COMMON CONDITIONS

Summary of document-wide changes:

- Updates to reflect GWRC & WCC feedback as shown in tracked changes and with reasons for changes noted.
- Updated time periods to be consistent throughout conditions (i.e. “5 years” (rather than “five years” or “five (5) years”).

Attachment F

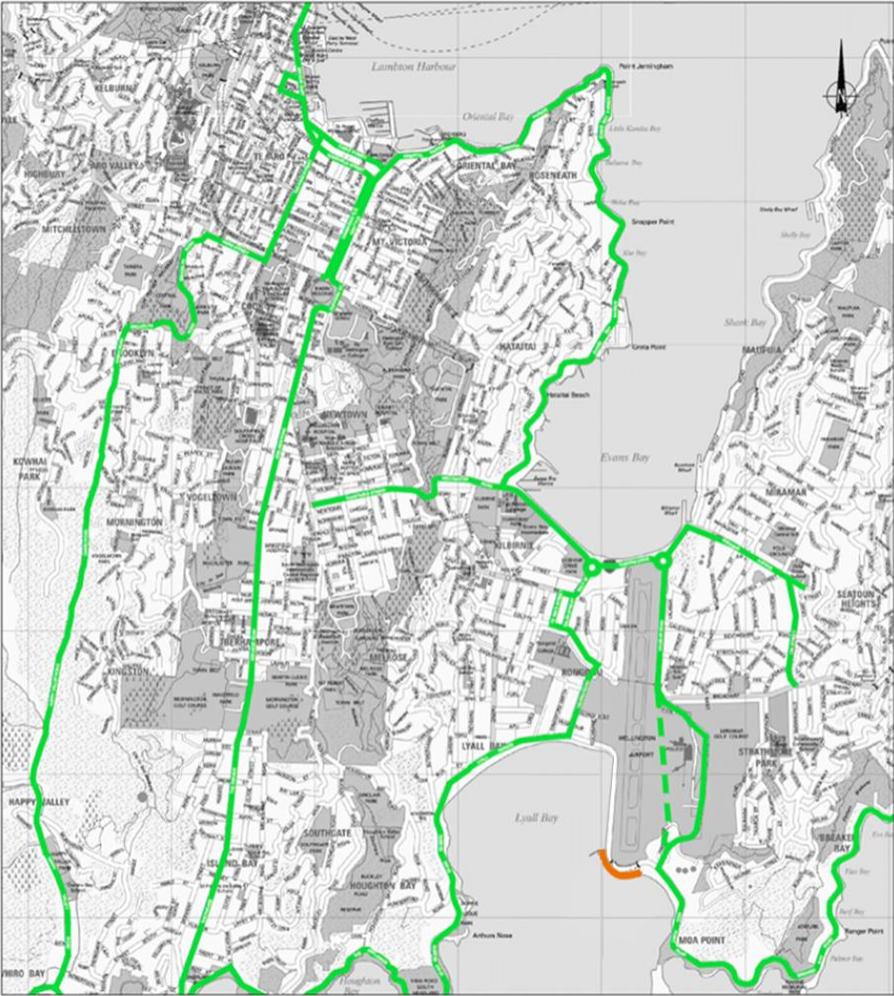
- Overdimension Vehicle Routes
- Site Location
- - - Updated Overdimension Vehicle Route
